**Safety Notice 1 of 1999:
SuperLite 17 A/B Neck Clamp 11 May, 1999**

Subject:
Weld Strength

Product Affected:
**SuperLite 17 A/B
Neck Clamp Assembly**

manufactured from 10/97 to 12/98

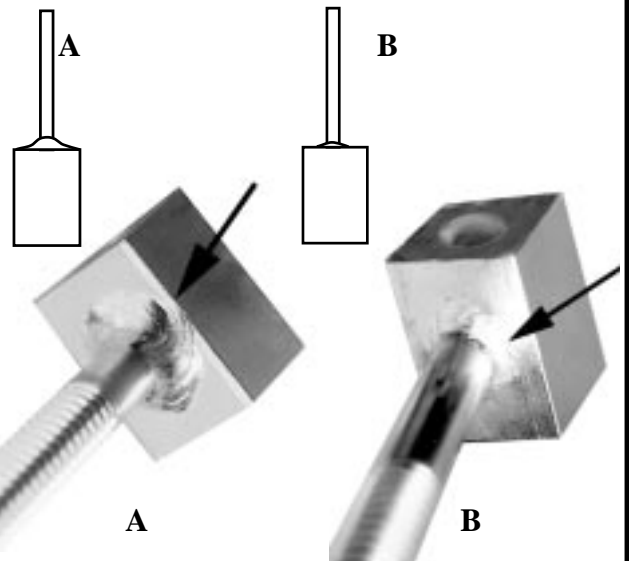
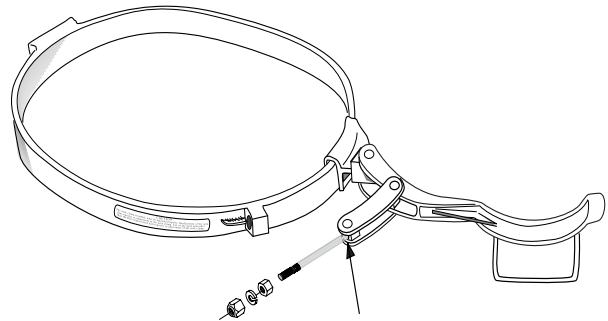
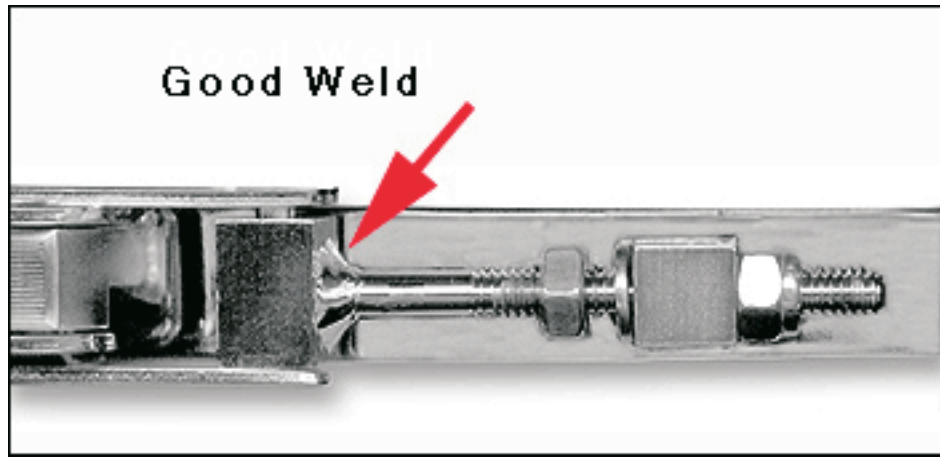
The purpose of this Safety Notice is to alert all end users and owners of Diving Systems International SuperLite 17 helmet neck clamps, DSI part # 505-055 to a potential problem with the welded stud on the neck clamp assembly

This weld should have 1/8" of material (1/8" fillet weld) all around the stud as shown in figure A. If your clamp has a weld like the one shown in figure B, (no extra material) please return it to your nearest Authorized DSI dealer immediately for inspection and replacement if necessary. For close up color images of the welds, see the **notices** section of our web site at www.Diving Systems.com

NOTE: The potential of possible failure of the weld shown in figure B increases when the users neck clamp is not properly adjusted. If you use any neck seal other than the standard DSI neck dams,

NOTE: The potential of possible failure of the weld shown in figure B increases when the user's neck clamp is not properly adjusted.

Inspect your neck clamp immediately.

YOU MUST RE-ADJUST YOUR NECK CLAMP ASSEMBLY FOR PROPER OPERATION!

Important Caution Note

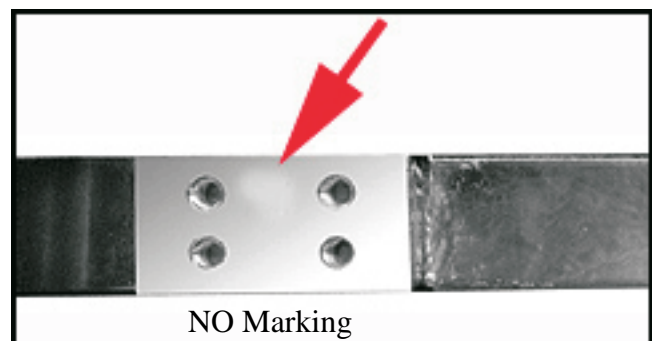
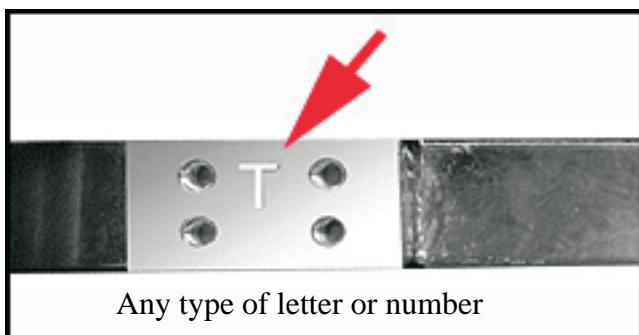
This reference guide is to eliminate confusion as to which neck clamps qualify for Warranty Replacement. Please check that neck clamps fit these specifications before sending them to DSI. Any type of marking on the hinge block area does not warrant replacement.

Neck Clamp with gusset
 (current product)

No gusset - No Warranty
 These are at least ten years old

This is the exact dimension of the stud that will help identify warranty replacement.
Anything other than this will not qualify under the safety notice.
